**ADDENDUM NO. 2**

**MONTE VISTA ELEMENTARY SCHOOL  
INTERIM HOUSING PROJECT  
GLENDALE UNIFIED SCHOOL DISTRICT**

DSA Appl. No.03-121306  
DSA File No. 19-41

**RESPONSES TO PRE-BID RFI'S**

drawing no.:  
**E0-3**  
drawing of

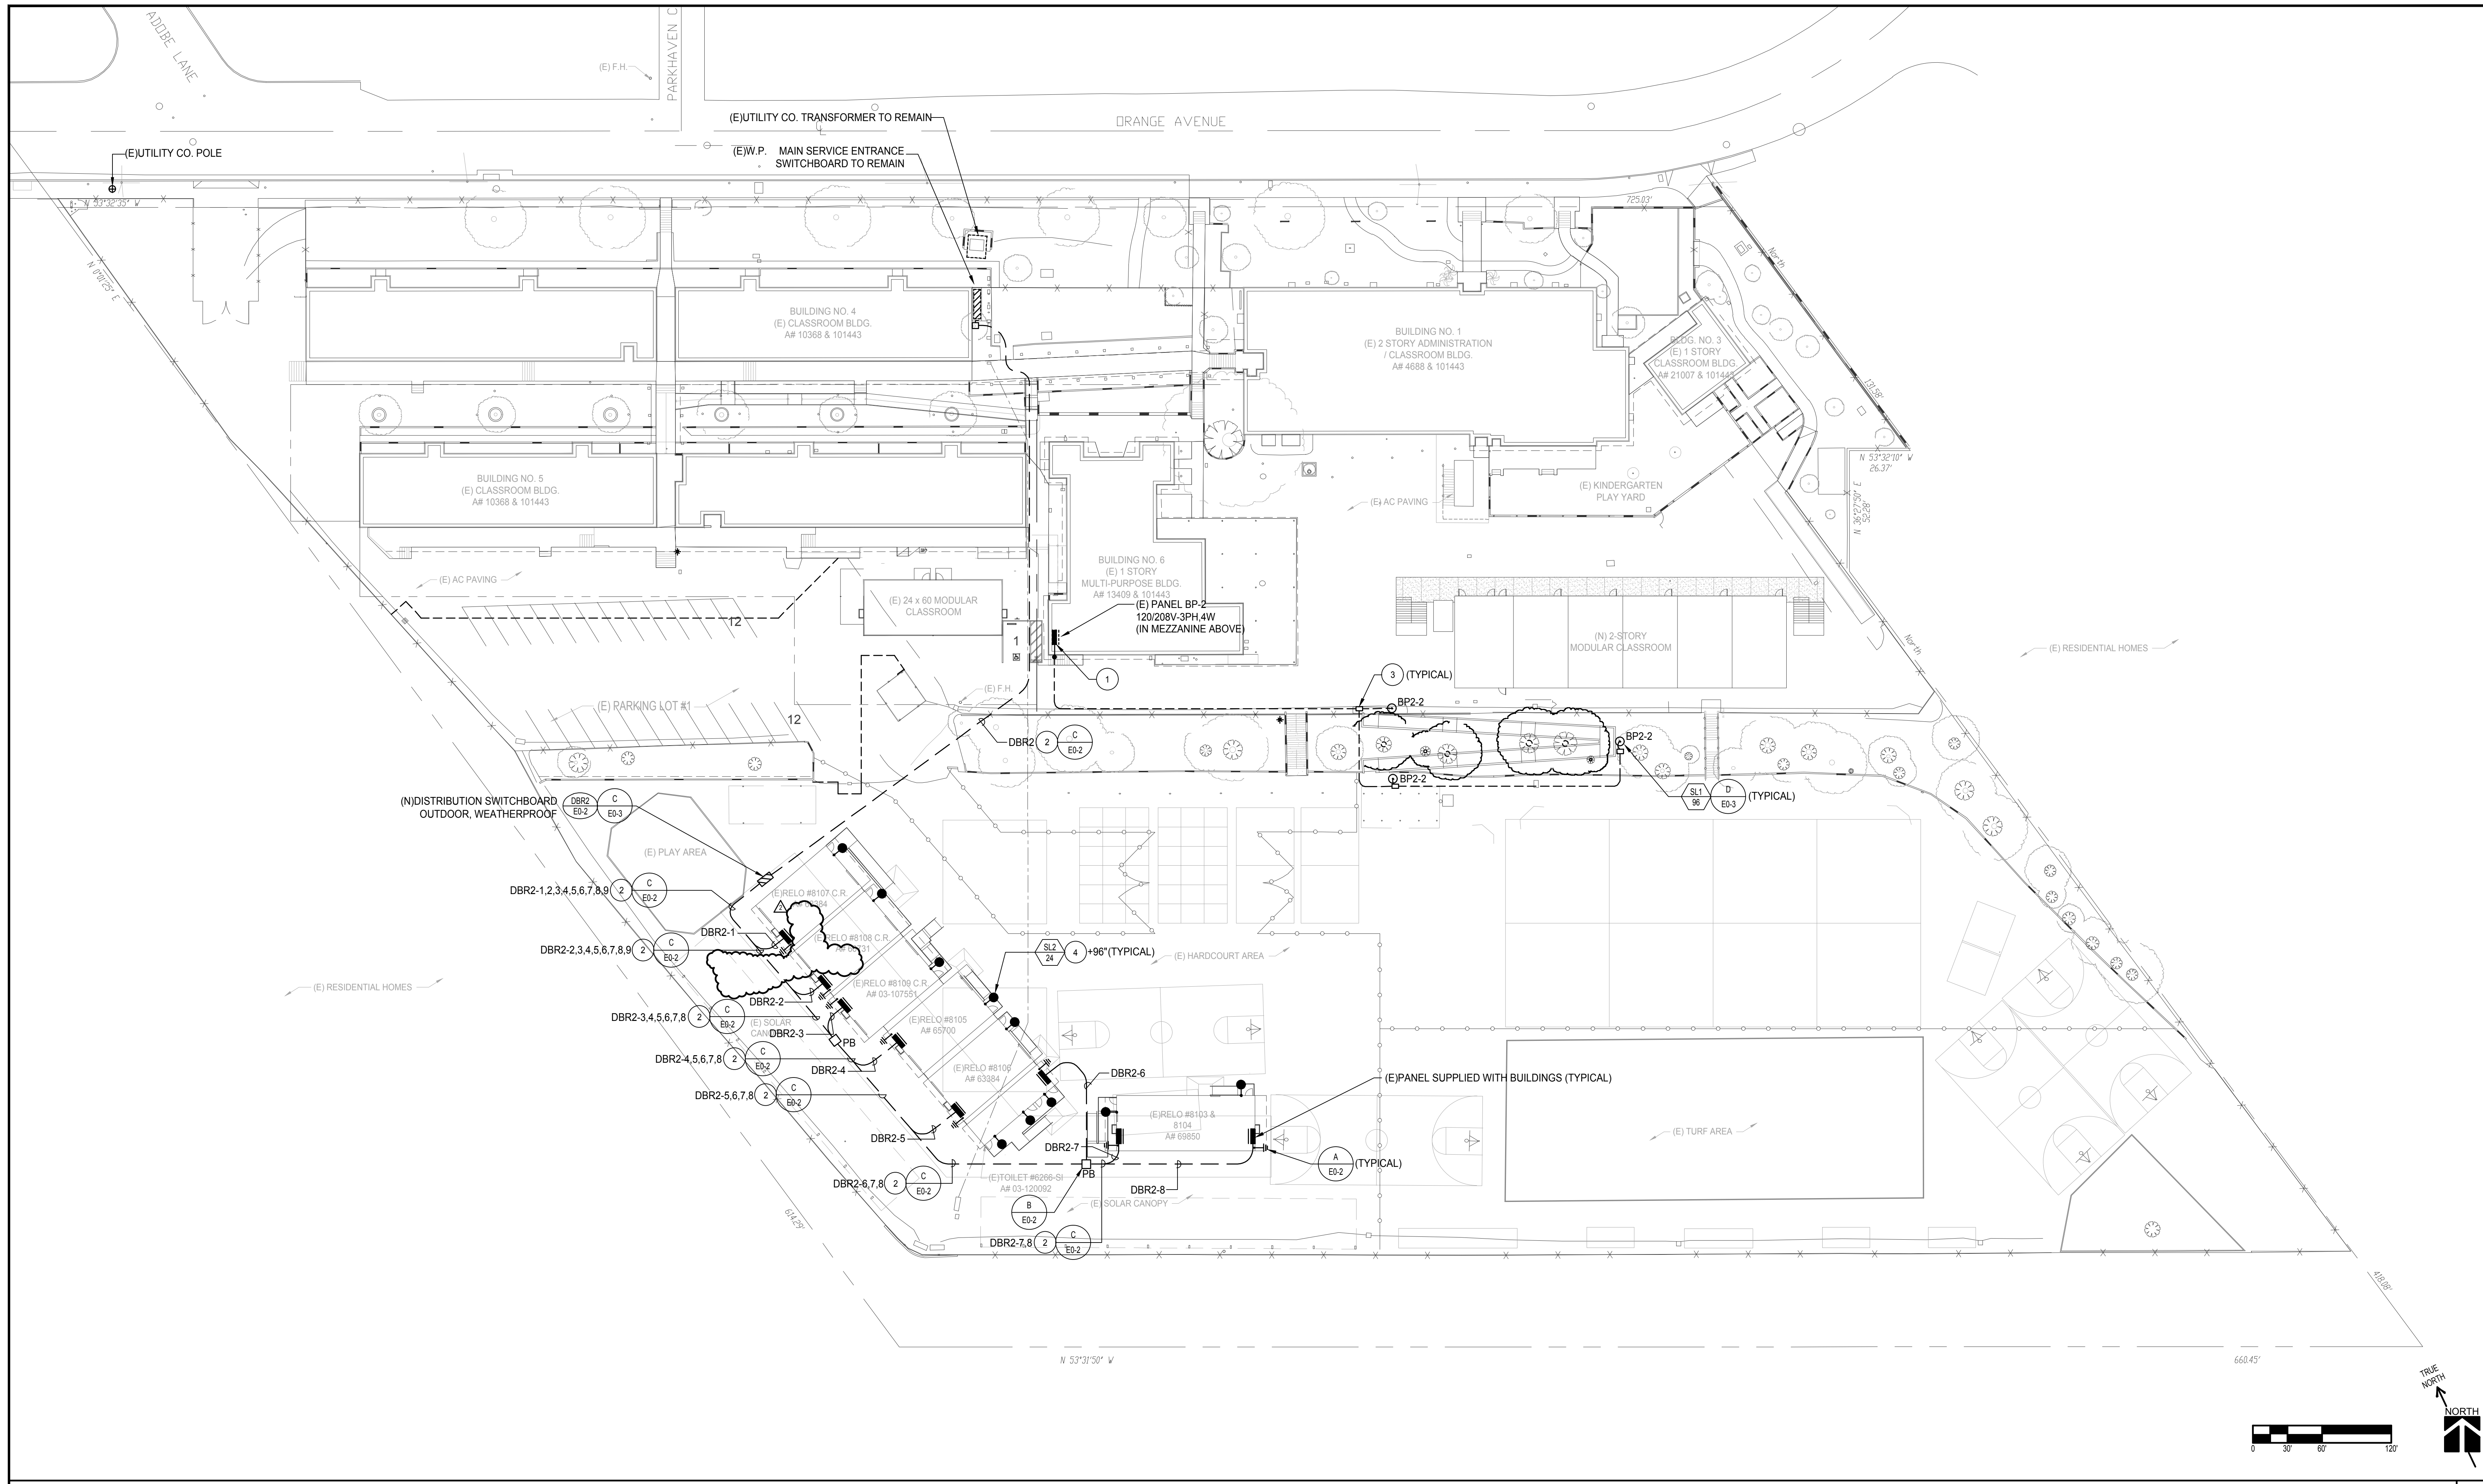
- as shown on plan.
  - b. Deleted Single Line Diagram Plan Notes 5,6, and 7 as shown on plan.
9. SHEET E0-3 – ELECTRICAL DETAILS  
Added Detail 'E' as shown on plans.
  10. SHEET E2-1 – OVERALL ELECTRICAL SITE PLAN  
Removed sewage ejector pump feed, disconnect switch and control panel from behind existing relocatable #8108 and deleted plan notes 5, 6, and 7.
  11. SHEET E2-2 – OVERALL TELECOM PLAN
    - a. Revised conduit and added plan note and detail callouts for clarification of conduit routing and signal systems connections as shown on plan.
    - b. Added Plan Notes 7,8, and 9 as shown on plan.

**Response** – Temp fencing shall be 6'-0" high.
10. Reference Sheet E0-2  
New 600 ampere 3 phase switchgear is located between RELO 8107 and existing playground. There are no raised pad details, anchoring details, nor fencing or bollard protection shown in drawings. Please advise.

**Response** – The mounting pad detail is shown as detail "C" on E0-3. this detail is called out on sheet E2-1. Architect to detail Bollards or fencing

drawing no.:  
**E2-1**  
drawing of

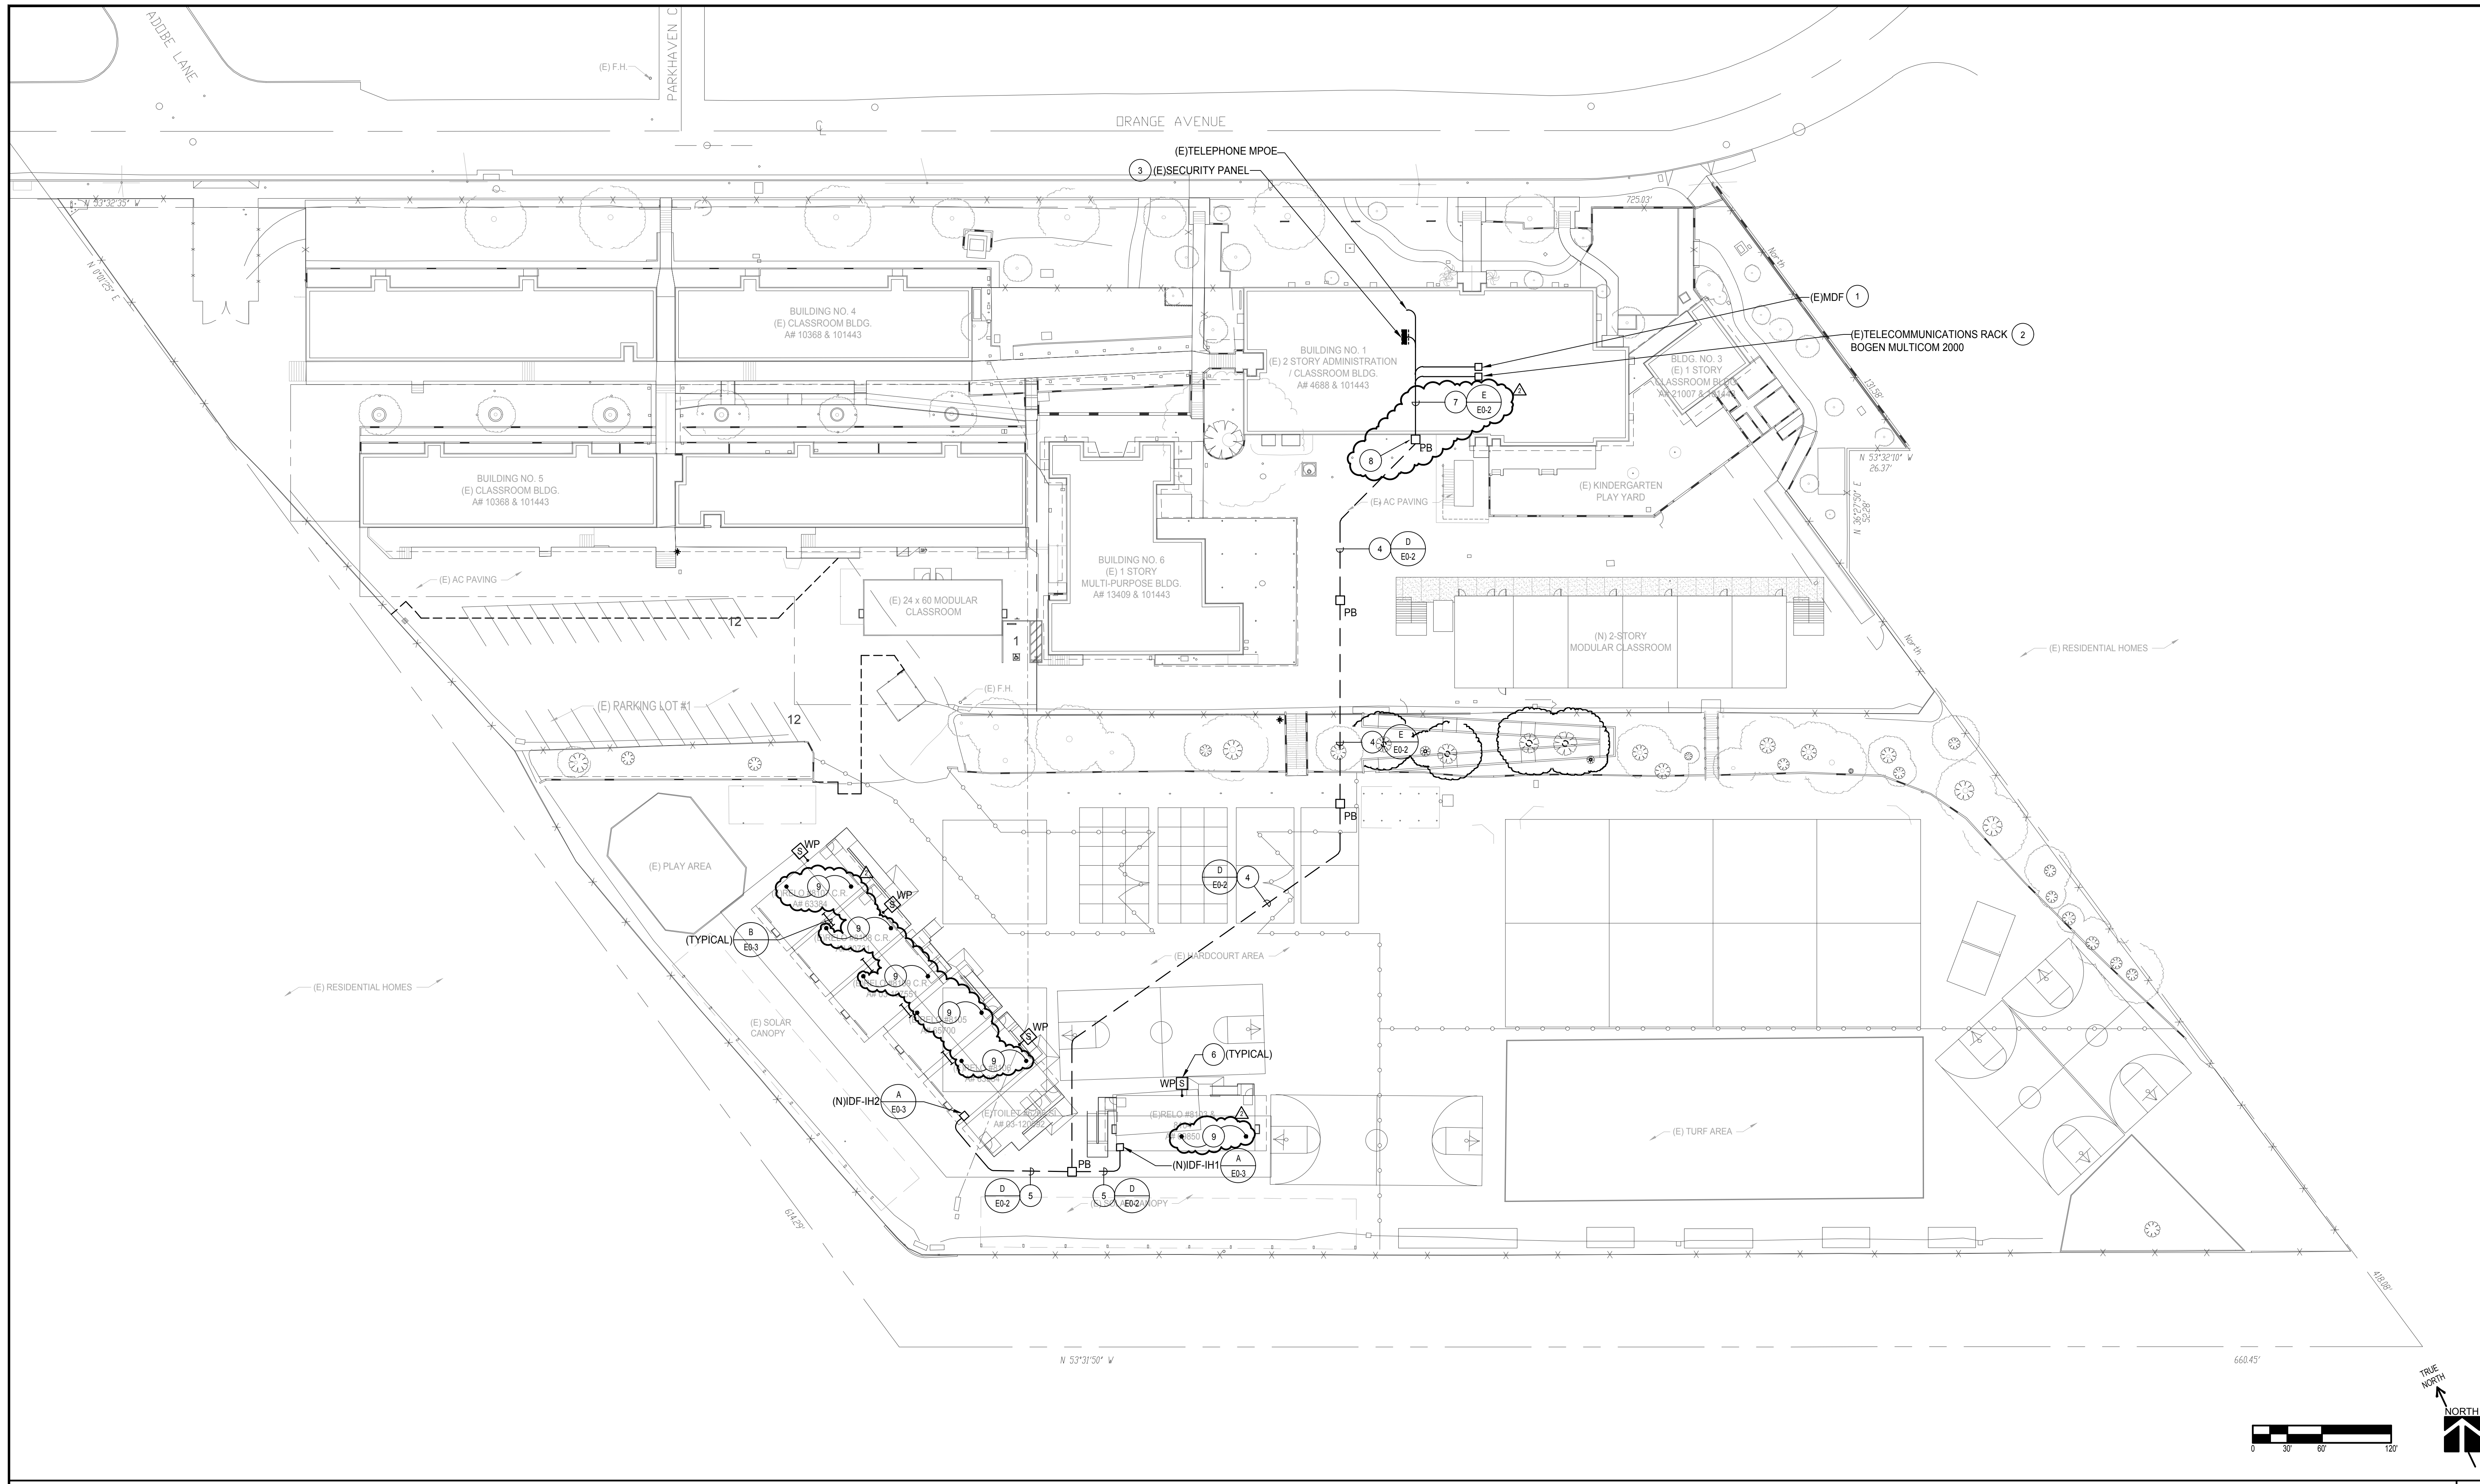
29. Reference Sheet E2-1 and E2-2  
A few locations are extremely difficult to trench for electrical and communication conduits. Specifically, the steep hill between the lower and upper campus and the steps by the main electrical room. See the attached map with areas circled in red. We request permission to bore conduits in these locations. Conduits would not be encased in these areas. Please advise.

**Response** – No exception taken to boring the conduits in the locations indicated, concrete encasement will not be required in the areas that have been bored. Trenching and concrete encasement will still be required in the areas not indicated in this RFI.
